City of Portland, Maine - Building or Use Permit Application

OCEAN RIDGE CONDOMINIUMS (UNITS 19-22)
852 OCEAN AVE, PORTLAND, ME.

OCEAN RIDGE CONDOMINIUMS 852 OCEAN AVENUE PORTLAND, MAINE

UNITS 19, 20, 21, 22

CHECK-LIST AGAINST ZONING ORDINANCE

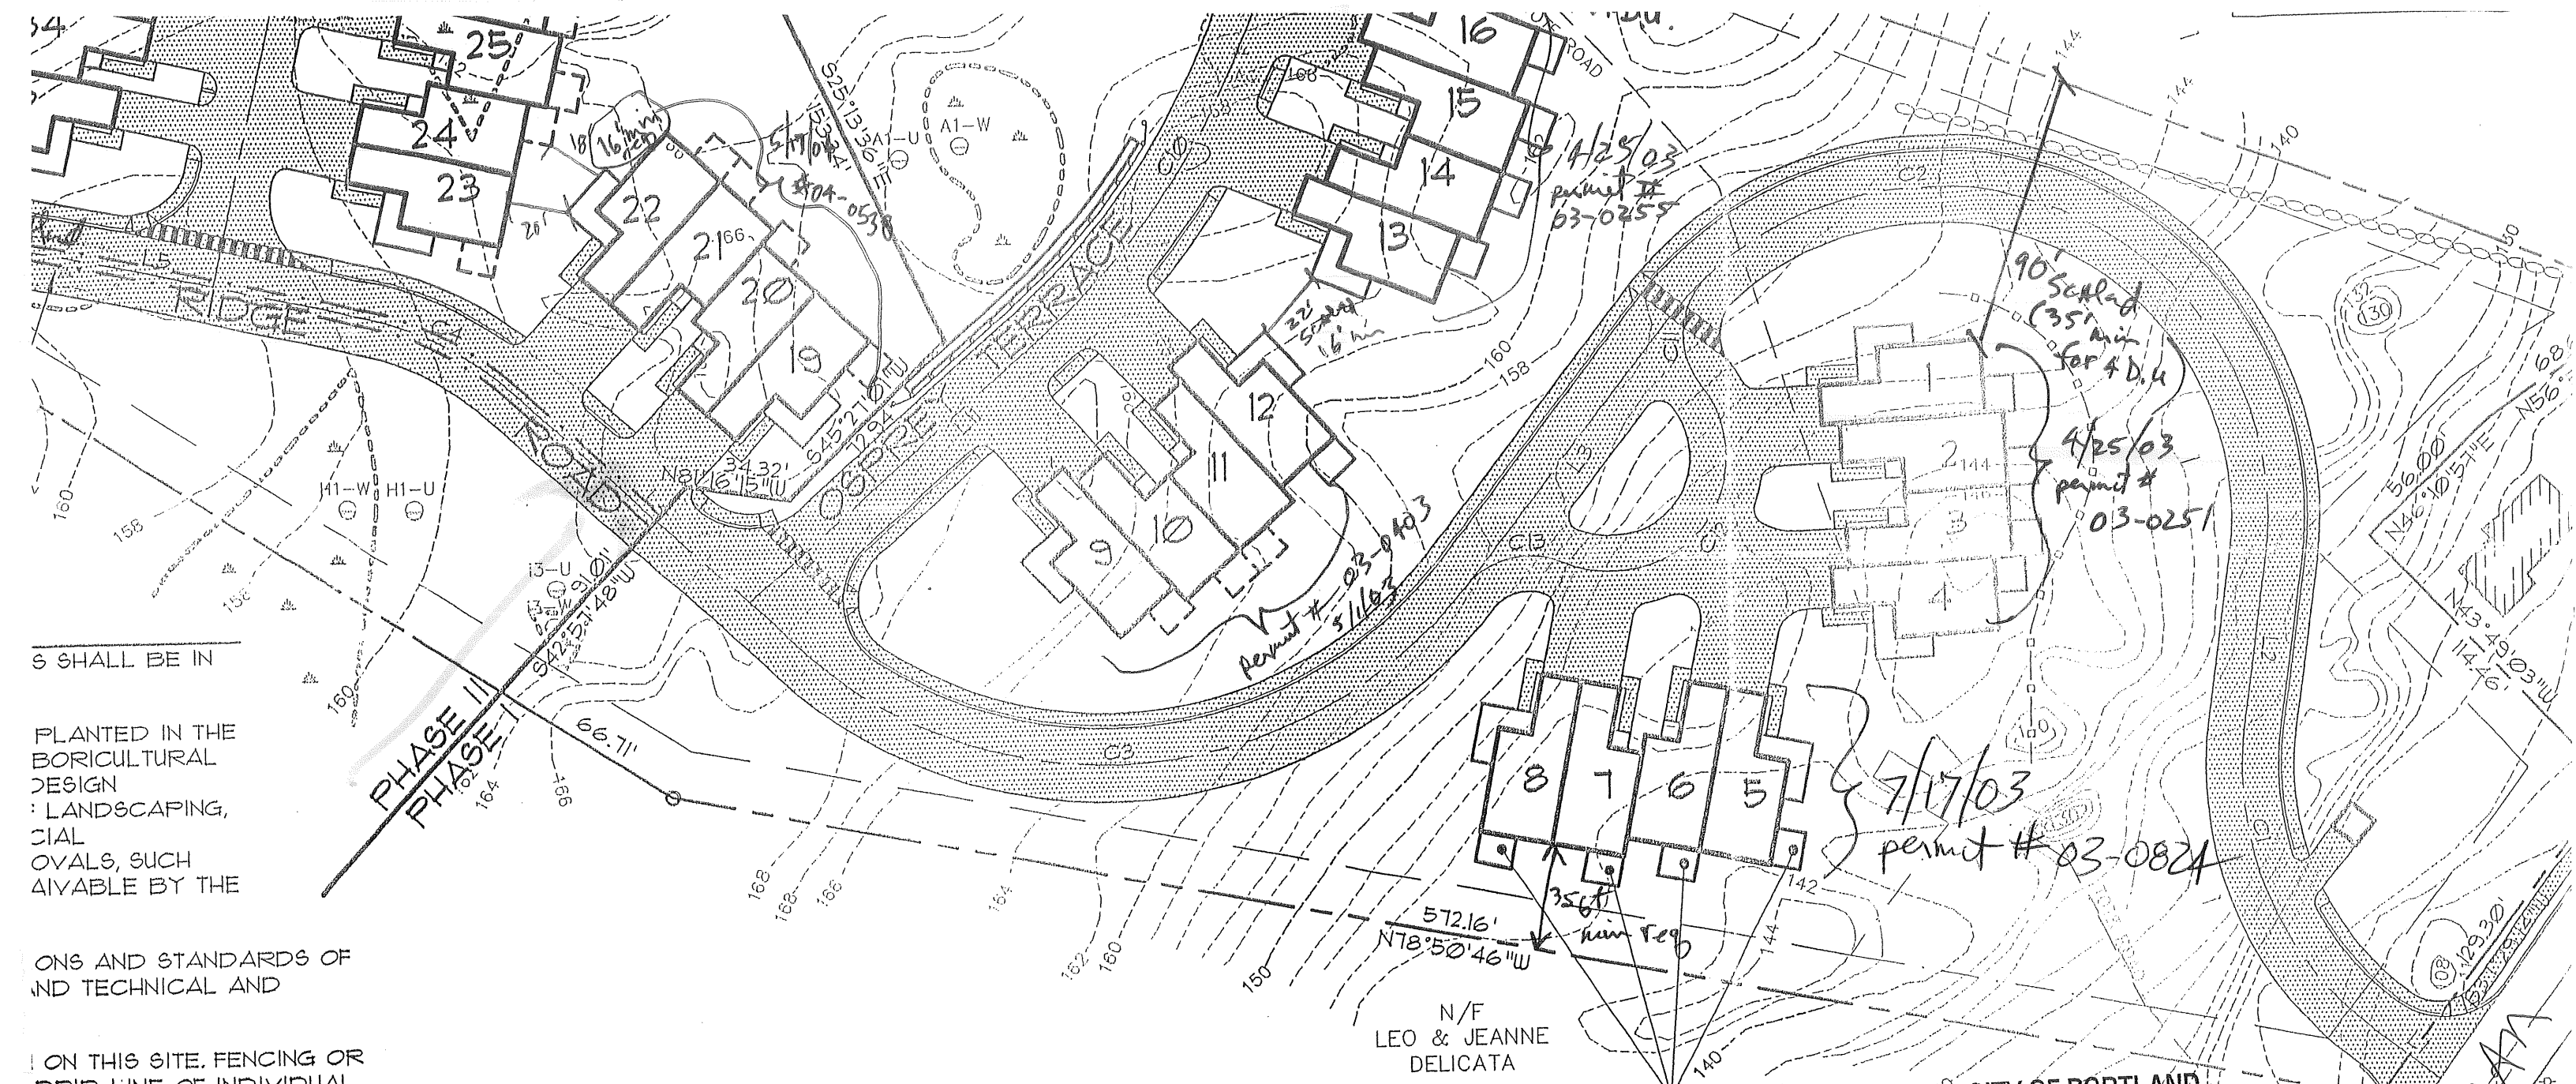
Front Yard - ① min Bldg setback from external subdivision property lines
35' for bldgs with 4+ units - 50' + shown

Side Yard - ② min distance between detached PRND D.U.s.
16' min req - 18' shown

Width of Lot - ③ recreation areas shall be located at least 25' from D.U. - The recreation areas very far away

Lot Coverage/ Impervious Surface - ④ - maximum number of units in a bldg
a) a PRND 5 acres or more = 6 units (4 shown)

Off-street Parking - ⑤ maximum length of a PRND Bldg - with a garage
140' max - 110' shown

(A) 1 HR. FIRE RATED DEMISING WALL
 U.L. No. U305
 (STC 90-55)

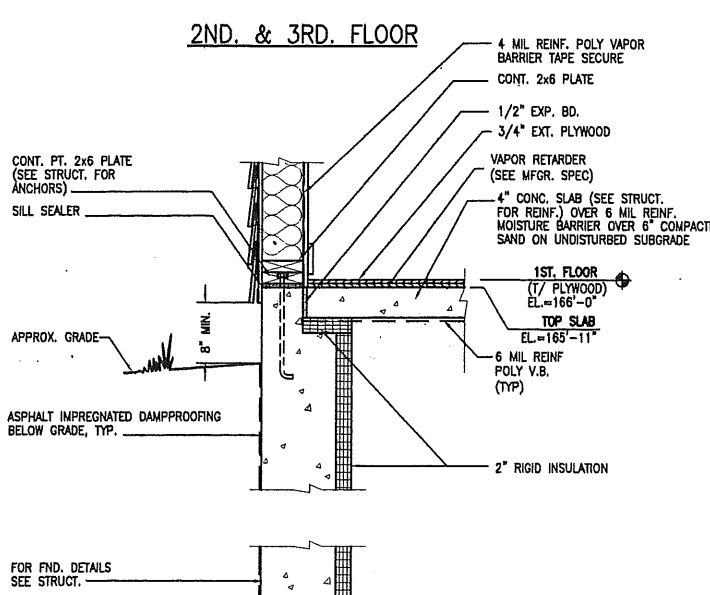
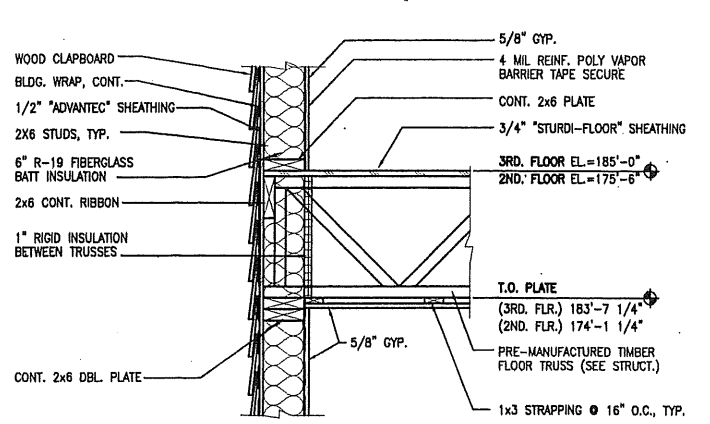
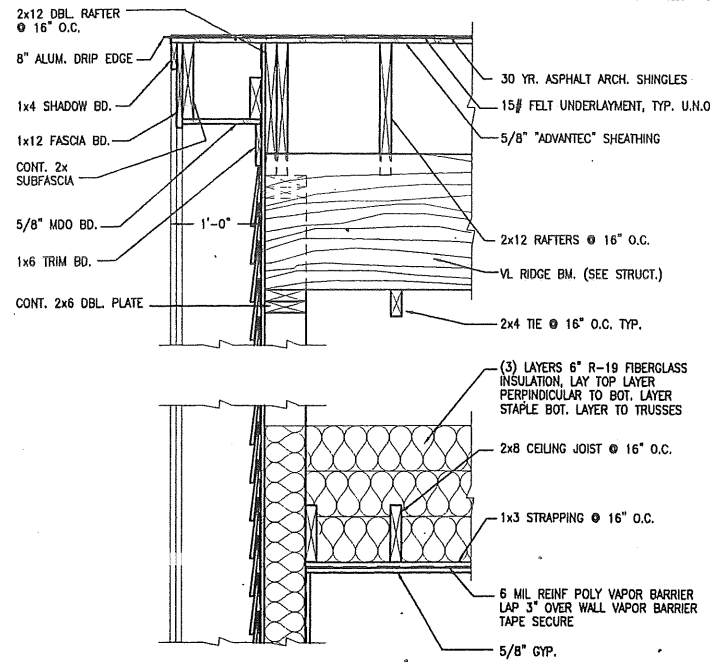
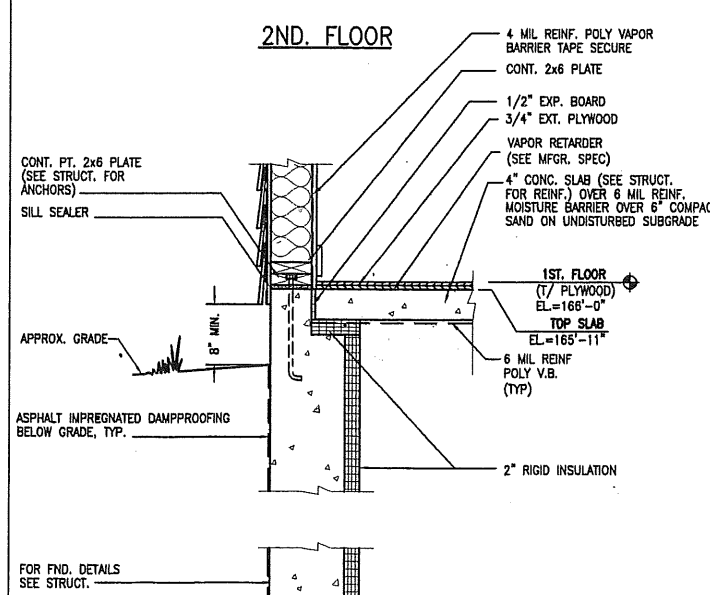
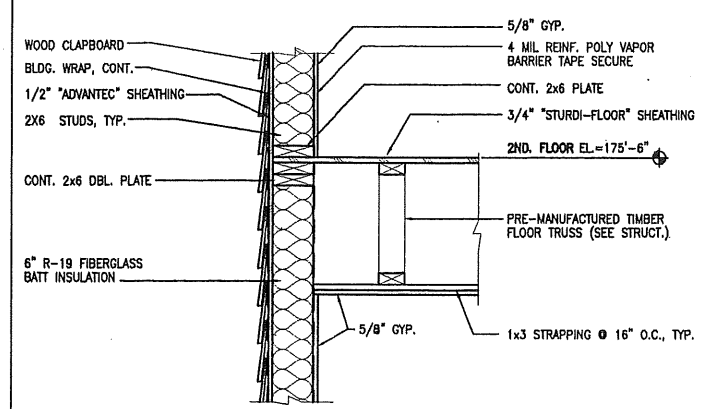
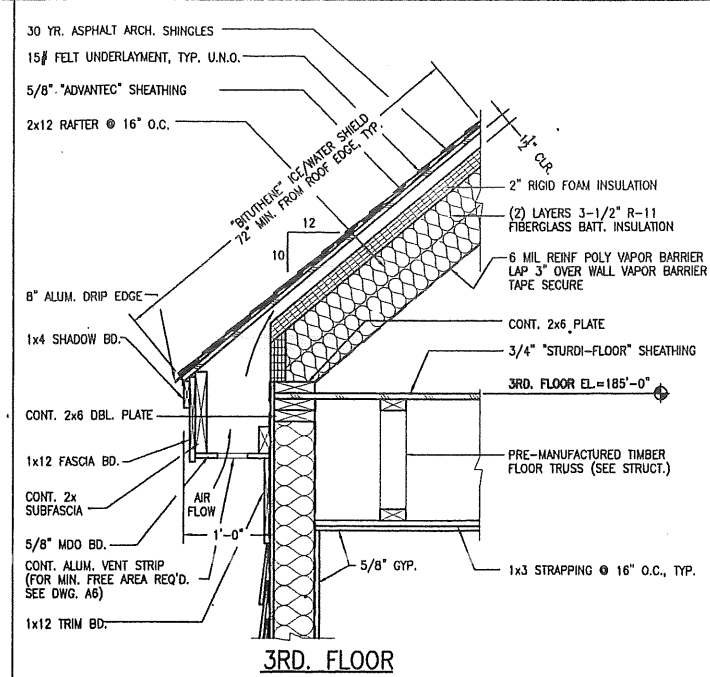
- 8) It appears that the floor ceiling assemblies need fire blocking as the space exceeds 500 Sq.ft.
 - 9) Does the wall system extend to the underside of the roof sheathing?

- 10) What is the STC of the wall assemblies?
 - 11) Page S9 Figure 5, using the FTW product, does the fire rated assembly include the GWB on the underside of the floor? (see section 711.4)

- 9) The Fire Rated Wall systems extends to the underside of the exterior roof sheathing typically as shown on Details 1 /A9 & Detail A/A10.
- 10) The STC of the Rated Fire Wall as shown on drawing A10 is 50-55. The other walls are between 30-35 depending on insulation and sheathing materials. If you need specific wall STC documentation, please contact this office.

- 11) The 1 Hour Fire Rated dwelling Unit demising walls extend continuous (including the fire retardant plywood) up to the underside of roof sheathing/ridge beam as indicated on drawings A9 & A10. The 5/8" gyp board on the ceilings between floors of the same dwelling unit is not part of the wall fire rated wall system. (Refer to Construction Permit # 13047 by State Fire Marshal's Office.)
